APPLICATION NO.	FILING DATE	FIRST NAMED INVENTOR	ATTORNEY DOCKET NO.	CONFIRMATION NO.
10/821,381	04/09/2004	Tony M. Gutierrez	5418.3001.002	1602

Office Action Summary

GUTIERREZ, TONY M.

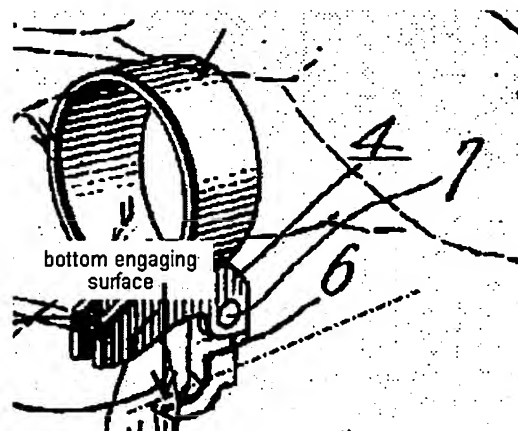
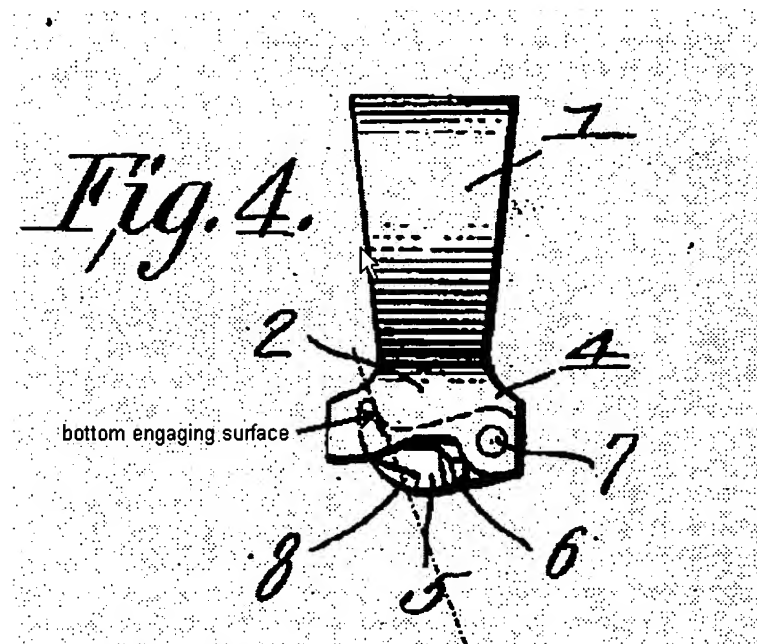
The figures below disclose the "generally" parallel bottom engaging surface. Note the dotted line that extends along the surface.

The prong of Brinn is integral with the band palm section as broadly claimed by applicant. Elements being pivotally connected does not preclude the elements as being integral since "integral" is defined as being a part of a whole, belonging to a part, or made up of parts.

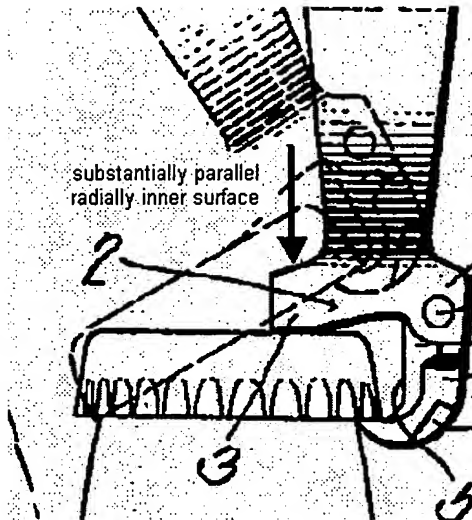
The bar of Brinn has a "substantially" parallel inner surface as shown below.
